Site Accessibility Evaluation

Fire Station 15

**4770 Scarlet Dr
Briargate, CO 80920**

SUBJECT: Fire Station 15 Self-Evaluation

Finding: 2

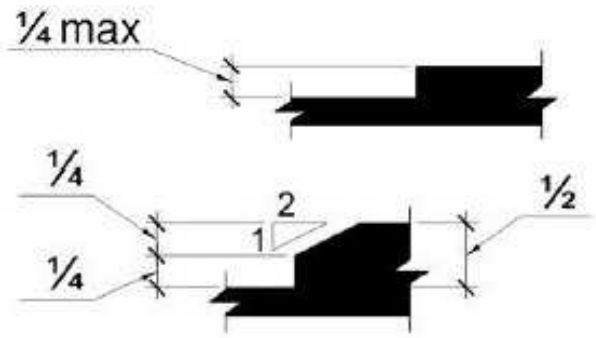
The walkway contains abrupt vertical edges and/or variations over a 1/4 inch.

In the sidewalk to the main entrance, there is a metal plate covering a drainage area. There is a 1" gap between the sidewalk and metal plate.

Fill the gap and fix the plate in place.

Finding: 3

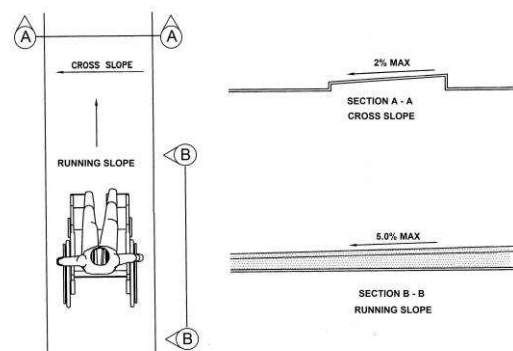
The accessible path of travel contains cross slopes greater than 2%.

There is 3% cross slope in the section of sidewalk at the driveway.

Remove and replace the sidewalk to achieve maximum 2% cross slope.

Finding: 4

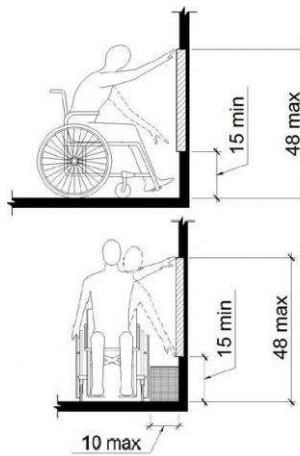
The door bell is positioned too high for either a side or front approach.

The door bell is mounted at 50" and is obstructed by the mailbox.

Lower the doorbell to 48" and move the mailbox so the door bell can be seen and accessed.

Finding: 5

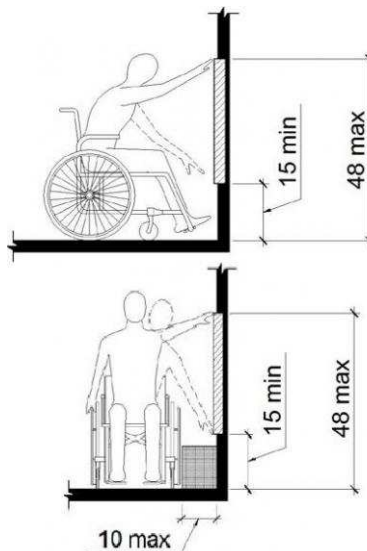
The door bell is not positioned correctly for either a side or front approach.

The door bell at the rear entrance is mounted at 49-1/2".

Lower the door bell to 48" maximum.
